# Access Compliance Report

## Public Rights-of-Way

### (Curb Ramps)

Intersection ID: 29364	Main Street: JOHN_MCGRAW_LN	Cross Street: SUMMIT_HILLS_DR	Location: S
ADA ID: 0B742B311D91	Ramp Type: Perp	Initial Pass/Fail: Fail	Overall Compliance: No
Severity Score: 8.75			
Codes/Mitigation Info/Possible Solution		Field Measurements/Component Compliance

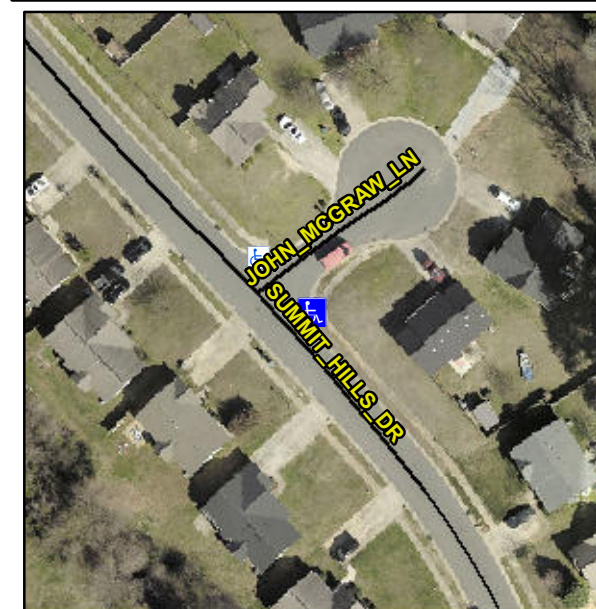
Compliance	Description	Data	Compliance	Description	Data
N/A	Ramp Length (in)	49.5	Yes	Ramp Slope (%)	6.3
No	Ramp Width (in)	46.0	Yes	Ramp XSlope (%)	1.4
N/A	Flare Type LT	N/A	N/A	Flare Type RT	N/A
N/A	Flare Slope LT (%)	N/A	N/A	Flare Slope RT (%)	N/A
N/A	Flare Traversable LT?	N/A	N/A	Flare Traversable RT?	N/A
N/A	Landing Length (in)	N/A	N/A	DWS Provided?	N/A
N/A	Landing Width (in)	N/A	N/A	DWS Contrast?	N/A
N/A	Landing Slope (%)	N/A	N/A	DWS Length (in)	N/A
N/A	Landing X Slope (%)	N/A	N/A	DWS Full Width?	N/A
N/A	Landing Curb? (Y/N)	N/A	N/A	DWS Offset (in)	N/A
N/A	Shared Landing?	N/A			
N/A	Gutter Ponding?	N/A	N/A	Gutter Slope (%)	N/A
N/A	Gutter Lip Ht (in)	N/A	N/A	Gutter X Slope (%)	N/A
N/A	Painted X Walk1?	No	N/A	Painted X Walk2?	N/A
	X Walk 1 Direction	To N		X Walk 2 Direction	N/A
N/A	X Walk 1 Width (in)	N/A	N/A	X Walk 2 Width (in)	N/A
	X Walk 1 Slope (%)	1.1		X Walk 2 Slope (%)	N/A
	X Walk 1 X Slope (%)	0.1		X Walk 2 X Slope (%)	N/A

N/A	Ramp inside XWalk1?	N/A	N/A	Ramp inside XWalk2?	N/A
	Road Slope (%)	N/A	N/A	Clear Space?	N/A
	Road X Slope (%)	N/A	N/A	Clear Space to XWalk (in)	N/A
N/A	Any Obstructions?	N/A	N/A	Storm Grate/Utility Hazard?	N/A
	Obstruction Type			Storm Grate/Utility Type	
		N/A			N/A
			Yes	Surface Condition? (G/P)	Good

**Remove & Replace Entire Ramp.**

**R304.5.1**
